Access Compliance Report

Public Rights-of-Way

(Curb Ramps)

Intersection ID: 42783	Main Street: OLD_STONE_CROSSING_DR	Cross Street: SAWMILL_TRACE_DR	Location: SE
ADA ID: 766FA0D9E6B2	Ramp Type: PerpDiag	Initial Pass/Fail: Fail	Overall Compliance: No
Severity Score: 35			
Codes/Mitigation Info/Possible Solution		Field Measurements/Component Compliance

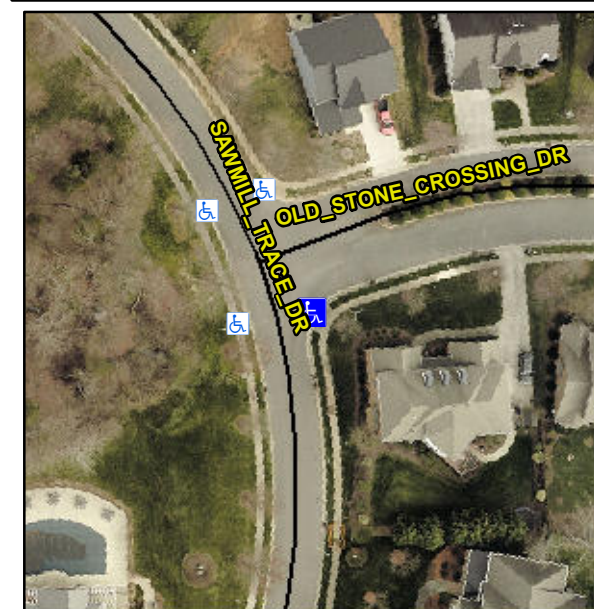
Not Found, R304.5.1, R304.2.2, R304.5.3

Compliance	Description	Data	Compliance	Description	Data
N/A	Ramp Length (in)	48.5	No	Ramp Slope (%)	14.1
No	Ramp Width (in)	45.5	No	Ramp XSlope (%)	4.2
N/A	Flare Type LT	N/A	N/A	Flare Type RT	N/A
N/A	Flare Slope LT (%)	N/A	N/A	Flare Slope RT (%)	N/A
N/A	Flare Traversable LT?	N/A	N/A	Flare Traversable RT?	N/A
N/A	Landing Length (in)	N/A	N/A	DWS Provided?	N/A
N/A	Landing Width (in)	N/A	N/A	DWS Contrast?	N/A
N/A	Landing Slope (%)	N/A	N/A	DWS Length (in)	N/A
N/A	Landing X Slope (%)	N/A	N/A	DWS Full Width?	N/A
N/A	Landing Curb? (Y/N)	N/A	N/A	DWS Offset (in)	N/A
N/A	Shared Landing?	N/A			
N/A	Gutter Ponding?	N/A	N/A	Gutter Slope (%)	N/A
N/A	Gutter Lip Ht (in)	N/A	N/A	Gutter X Slope (%)	N/A
N/A	Painted X Walk1?	No	N/A	Painted X Walk2?	No
	X Walk 1 Direction	To N		X Walk 2 Direction	To W
N/A	X Walk 1 Width (in)	N/A	N/A	X Walk 2 Width (in)	N/A
	X Walk 1 Slope (%)	4.3		X Walk 2 Slope (%)	0.5
	X Walk 1 X Slope (%)	0.1		X Walk 2 X Slope (%)	3.8

Remove & Replace Curb Ramp With Two New Directional Ramps or Equivalent.
